ADDENDUM NUMBER 1

- 1.01 DATE: April 7, 2015
- 1.02 PROJECT: Interior Renovations to the Mimosa - G Residence
Ramapo College of New Jersey
- 1.03 SNS PROJECT NUMBER: 4698G

INTERIOR RENOVATIONS
AT THE
MIMOSA - G RESIDENCE

Dwg. Title
ENLARGED FIRST & SECOND FLOOR
HVAC PLANS

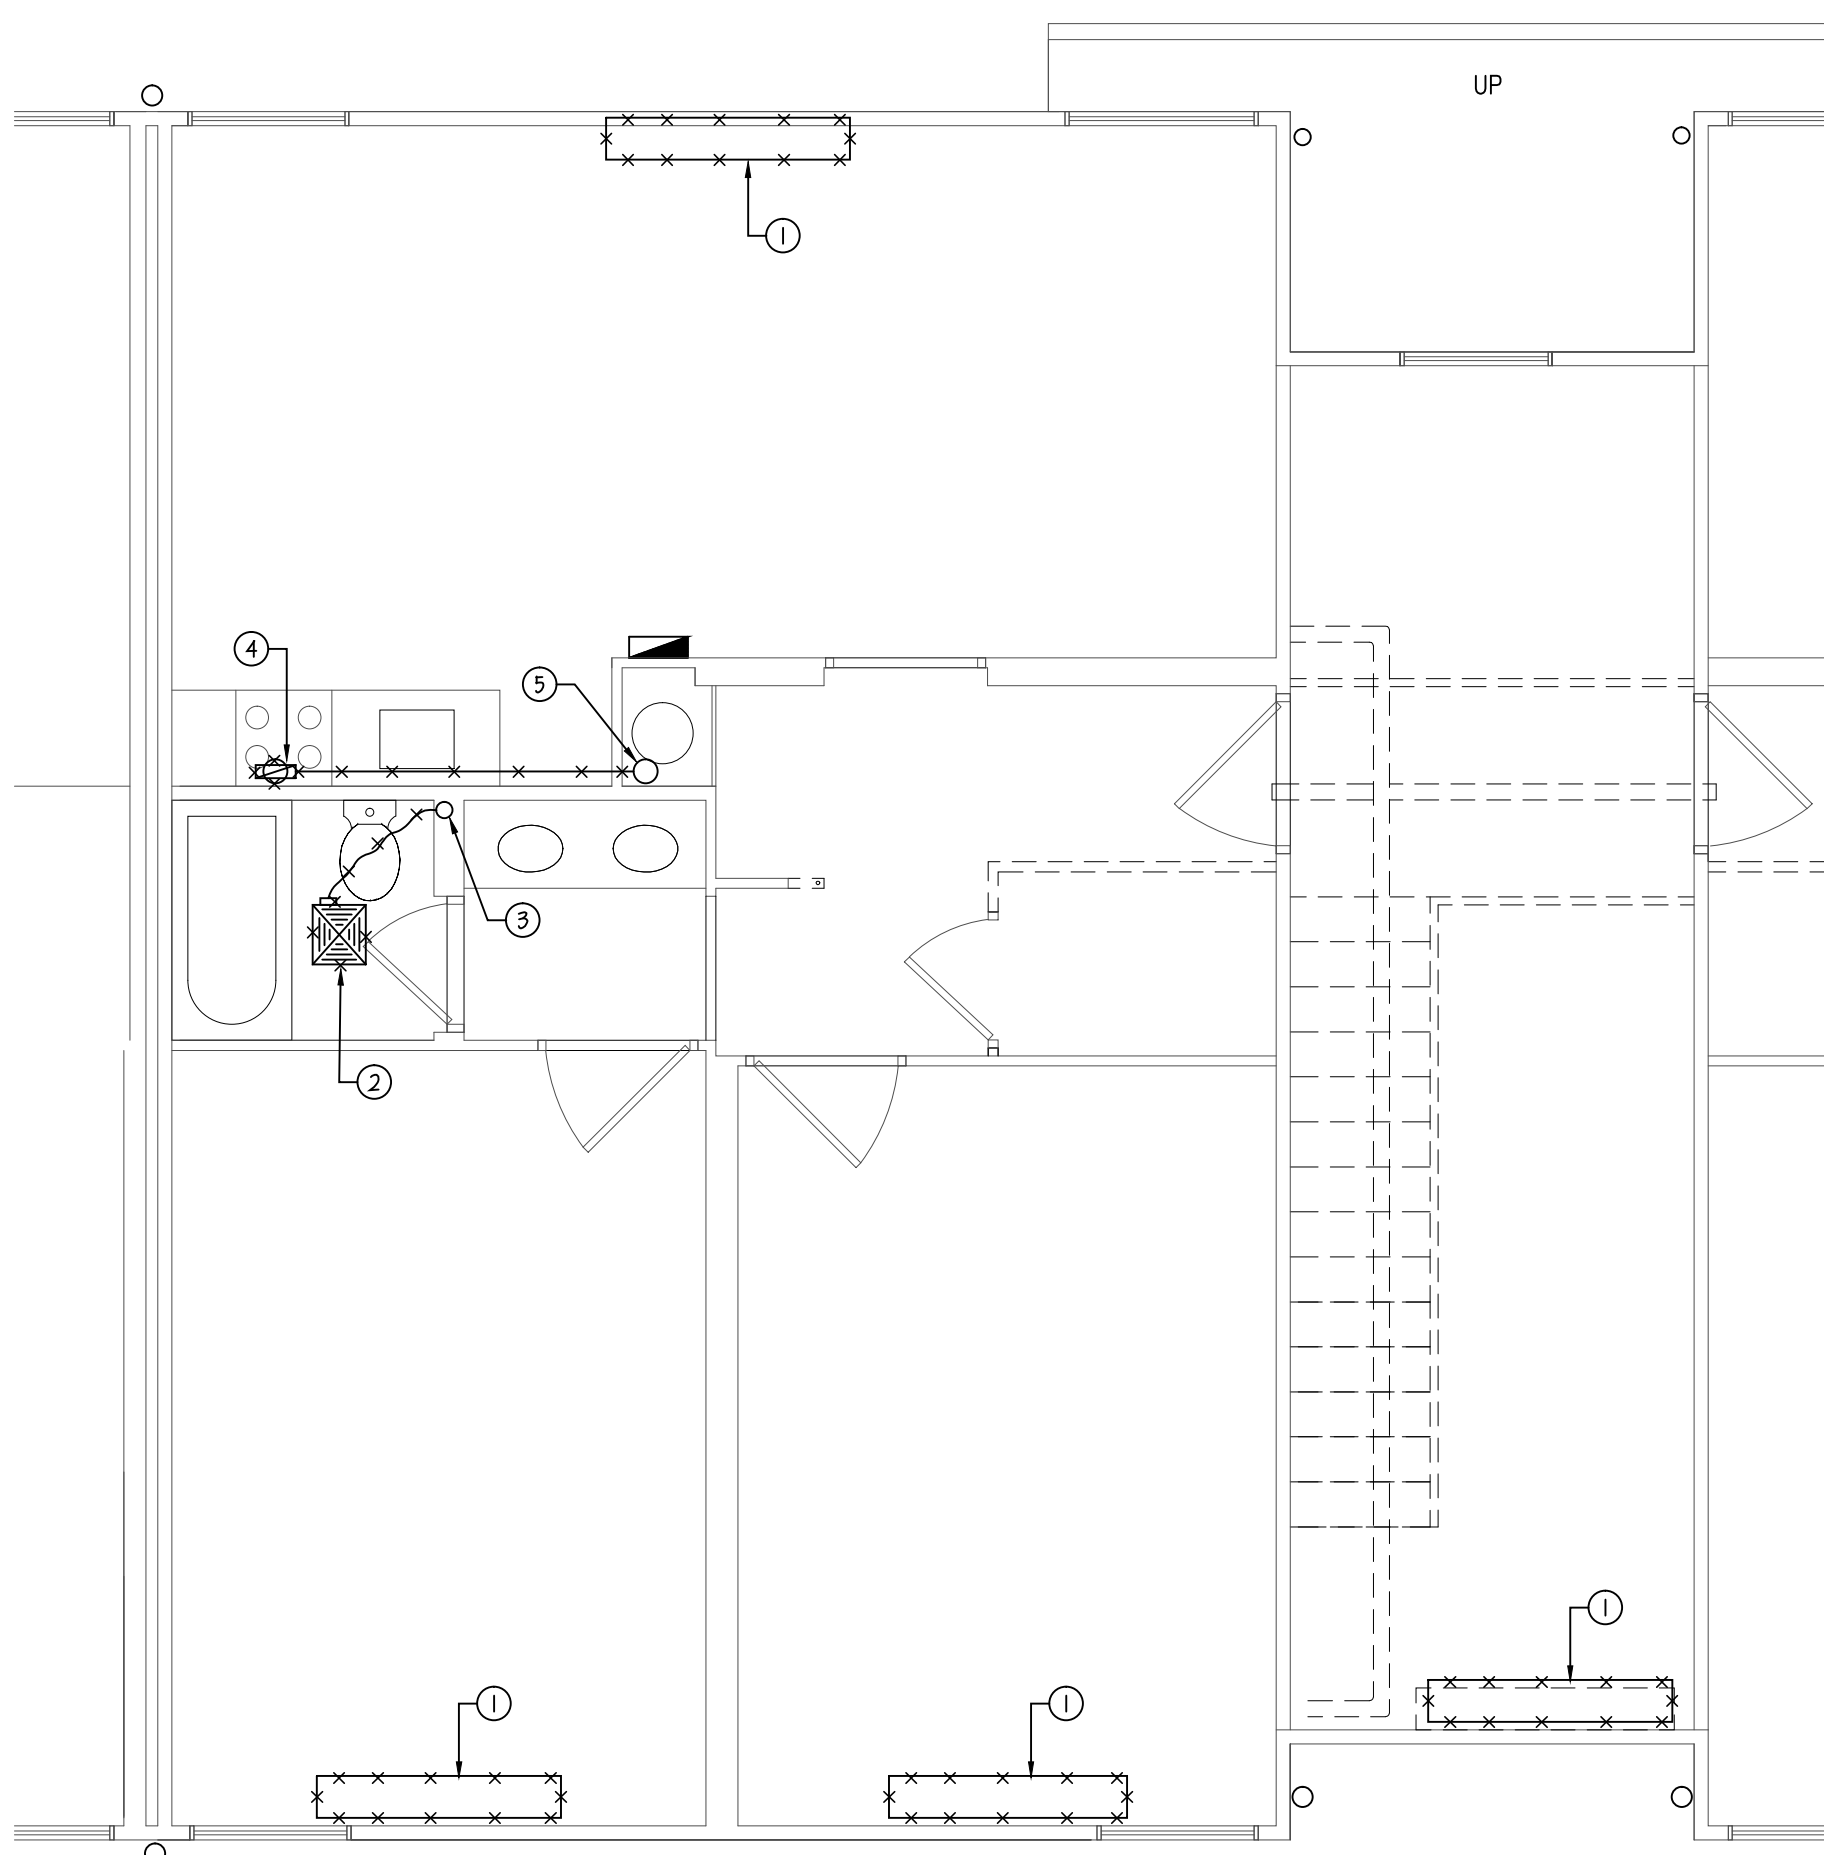
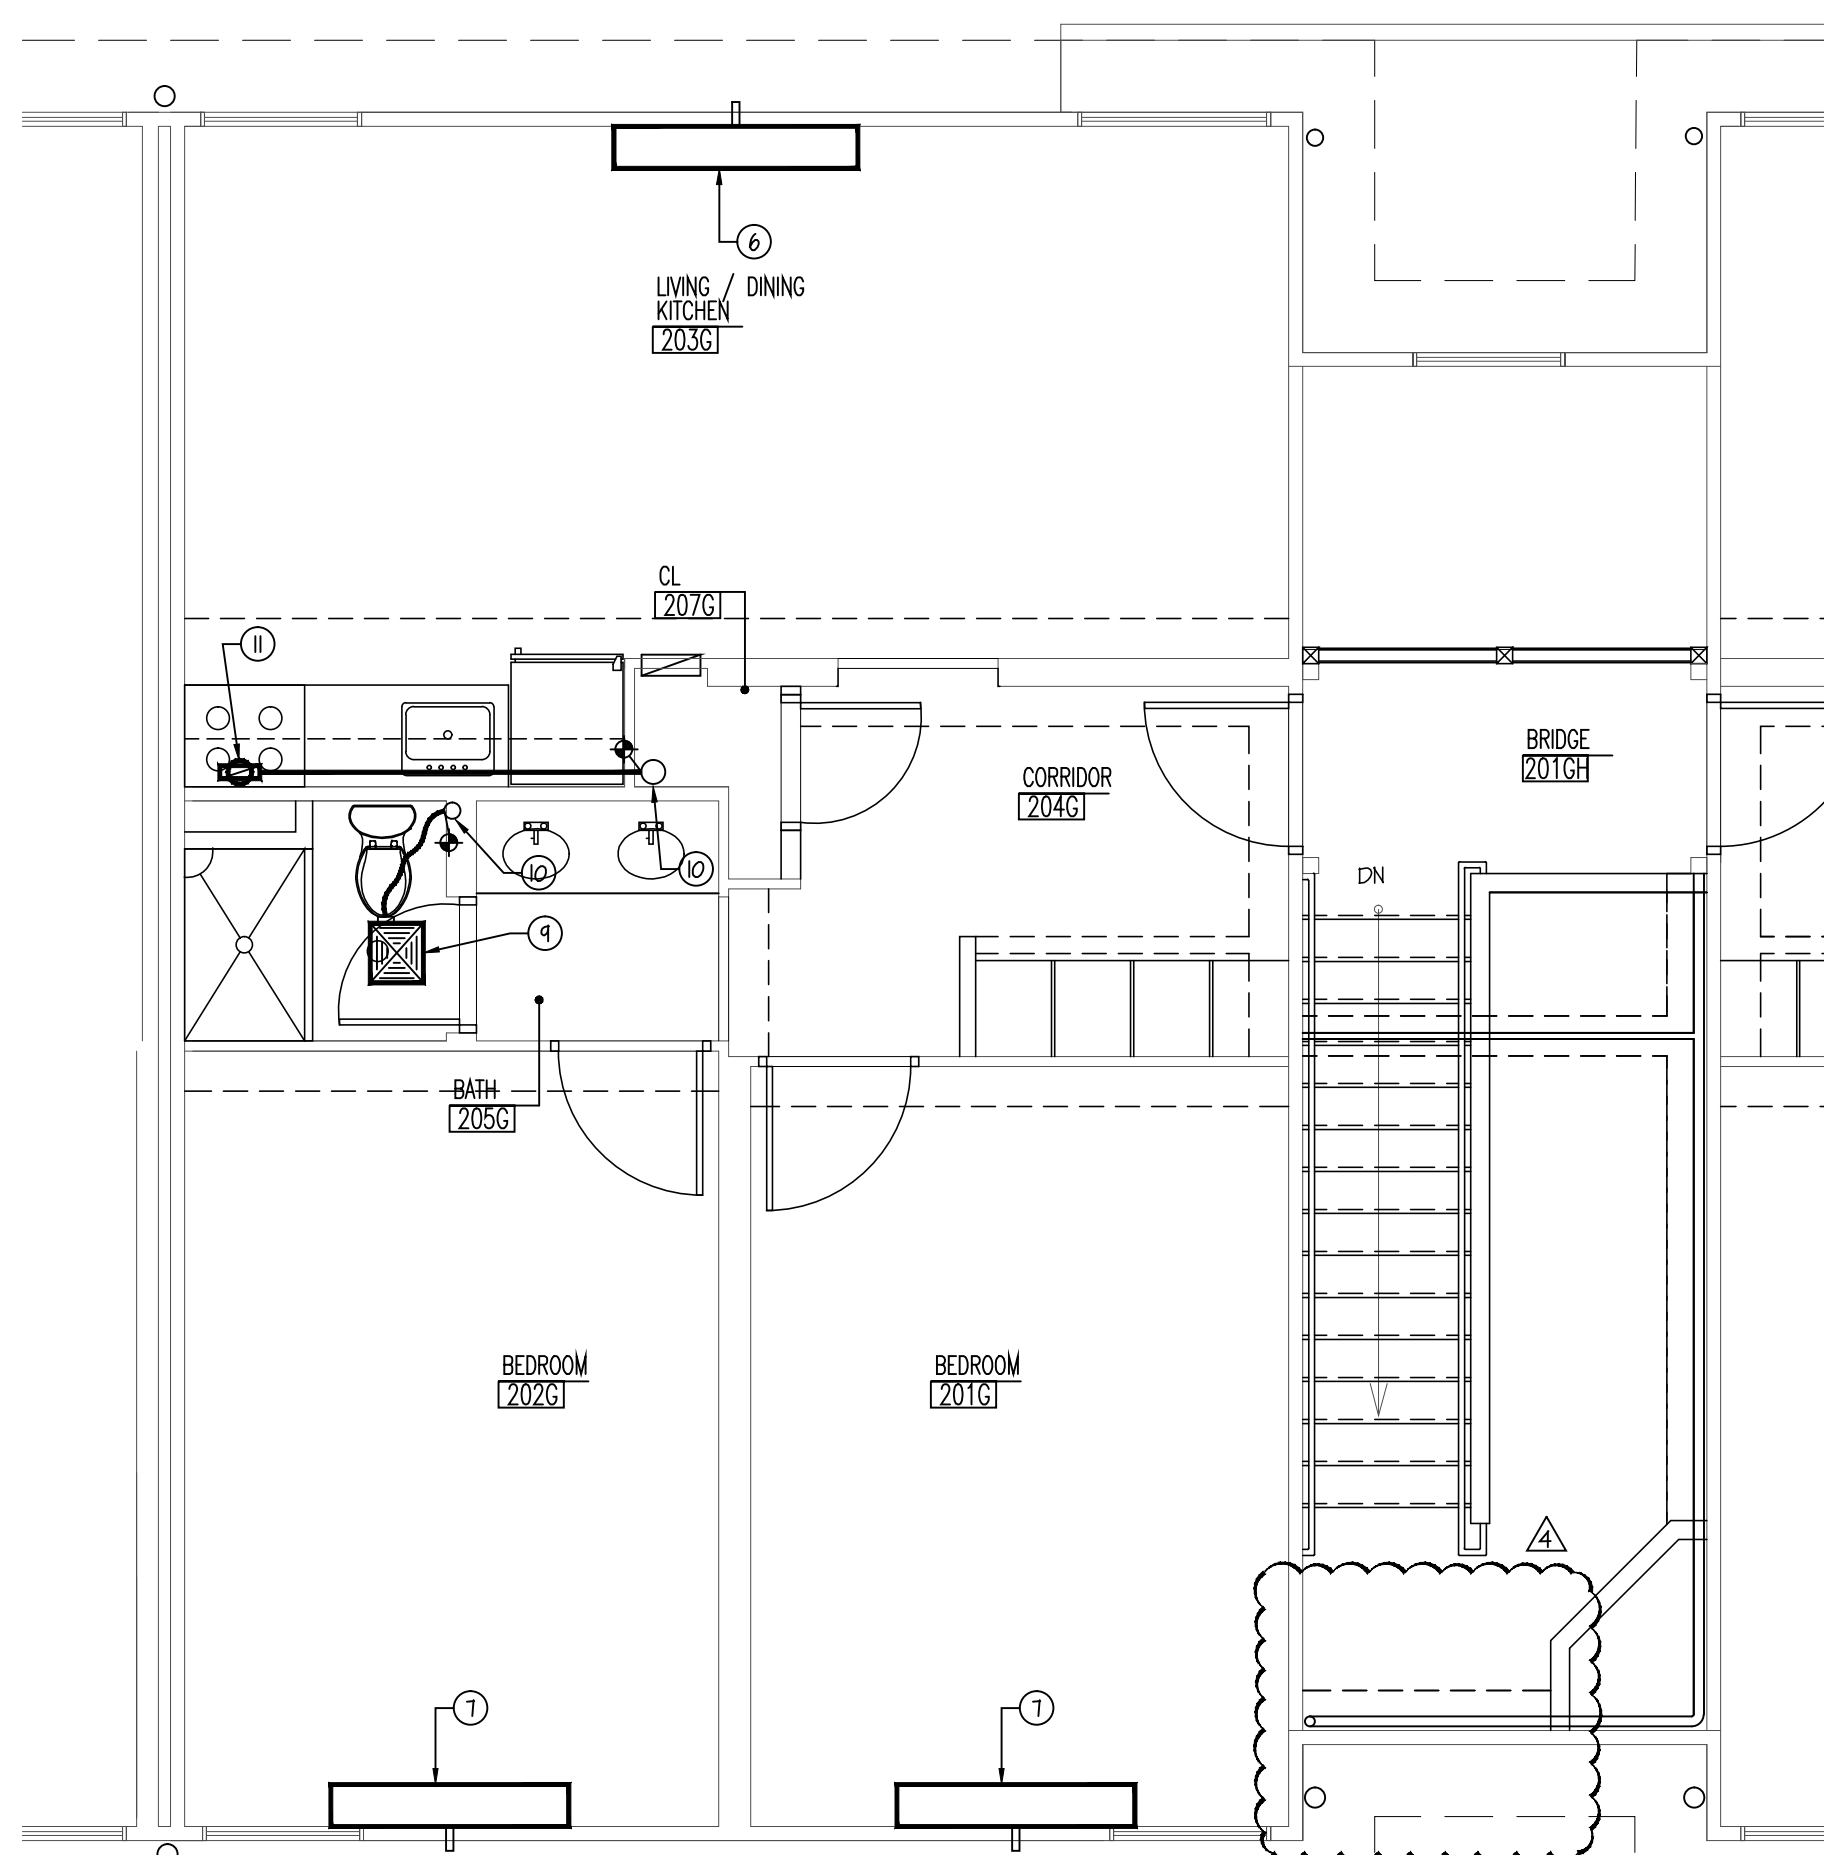
- 5.1. Added exhaust fan EF-1 to IT Closet, key notes and associated fan schedule.
6. DRAWING M200, ENLARGED FIRST & SECOND FLOOR HVAC PLANS:
 - 6.1. Added note indicating that all demolition work is by others under separate contract and filed under separate DCA permit application.

- 6.2. Removed unit ventilator from “Enlarged Second Floor HVAC Plan” located in Bridge 201GH.
7. DRAWING P200, ENLARGED FIRST & SECOND FLOOR PLUMBING PLANS:
